CITY PLANNING COMMISSION

- APPLICATION:
1. Negative Declaration;
 2. Amendment of the 1965 Sutterville Heights Community Plan from Light Density Residential to Multiple-Family Residential designation;
 3. Rezone 0.4+ acres from Single Family (R-1) and Light Density Multiple-Family (R-3) to Garden Apartments (R-2A) or more restrictive zone;
 4. Tentative Map to divide 0.4+ acres into one common lot and seven townhouse lots for townhouse condominium development;
 5. Special Permit for townhouse development.

LOCATION: 1927 Wentworth Avenue

PROPOSAL: The applicant is requesting the necessary entitlements to develop a seven unit, two-story townhouse condominiums in the R-2A zone.

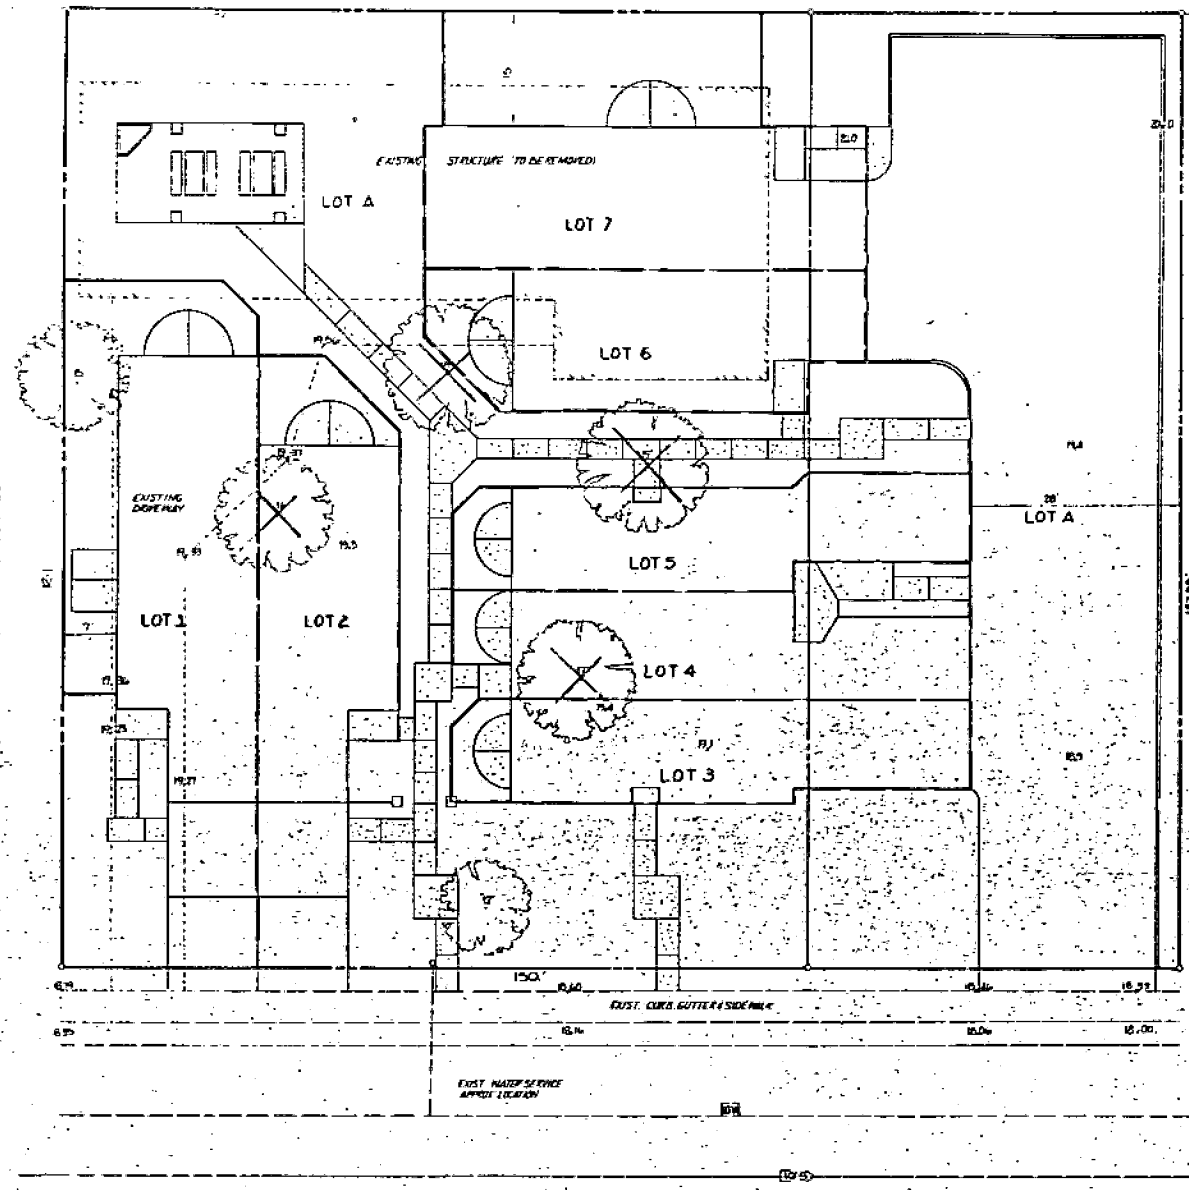
4. In order to provide the necessary 26 feet of back-out maneuvering distance for the three garages facing east (site plan shows 24 feet), the site plan needs to be revised by shifting the proposed structures two feet to the west.

- a. The applicant shall increase back-out maneuvering distance for three garages of triplex structure to 26 feet. A revised site plan indicating this shall be submitted to staff for review and approval.
